Access Compliance Report

Public Rights-of-Way

(Curb Ramps)

Intersection ID: 5407	Main Street: J_W_CLAY_BV	Cross Street: J_M_KEYNES_DR	Location: W
ADA ID: AA87A3E7DDE8	Ramp Type: Perp	Initial Pass/Fail: Fail	Overall Compliance: No
Severity Score: 33.75			
Codes/Mitigation Info/Possible Solution		Field Measurements/Component Compliance

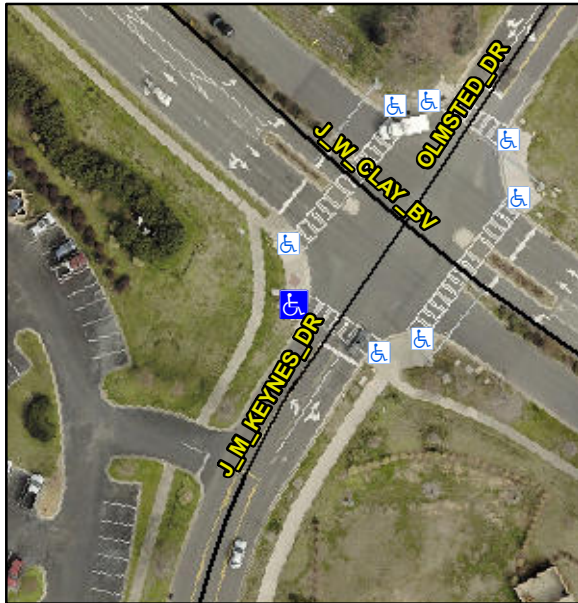
R304.5.1, R304.2.2

Compliance	Description	Data	Compliance	Description	Data
N/A	Ramp Length (in)	110.0	No	Ramp Slope (%)	16.5
No	Ramp Width (in)	47.5	Yes	Ramp XSlope (%)	1.1
N/A	Flare Type LT	N/A	N/A	Flare Type RT	N/A
N/A	Flare Slope LT (%)	N/A	N/A	Flare Slope RT (%)	N/A
N/A	Flare Traversable LT?	N/A	N/A	Flare Traversable RT?	N/A
N/A	Landing Length (in)	N/A	N/A	DWS Provided?	N/A
N/A	Landing Width (in)	N/A	N/A	DWS Contrast?	N/A
N/A	Landing Slope (%)	N/A	N/A	DWS Length (in)	N/A
N/A	Landing X Slope (%)	N/A	N/A	DWS Full Width?	N/A
N/A	Landing Curb? (Y/N)	N/A	N/A	DWS Offset (in)	N/A
N/A	Shared Landing?	N/A			
N/A	Gutter Ponding?	N/A	N/A	Gutter Slope (%)	N/A
N/A	Gutter Lip Ht (in)	N/A	N/A	Gutter X Slope (%)	N/A
N/A	Painted X Walk1?	No	N/A	Painted X Walk2?	N/A
	X Walk 1 Direction	To SE		X Walk 2 Direction	N/A
N/A	X Walk 1 Width (in)	N/A	N/A	X Walk 2 Width (in)	N/A
	X Walk 1 Slope (%)	1.2		X Walk 2 Slope (%)	N/A
	X Walk 1 X Slope (%)	2.3		X Walk 2 X Slope (%)	N/A

Remove & Replace Entire Ramp.
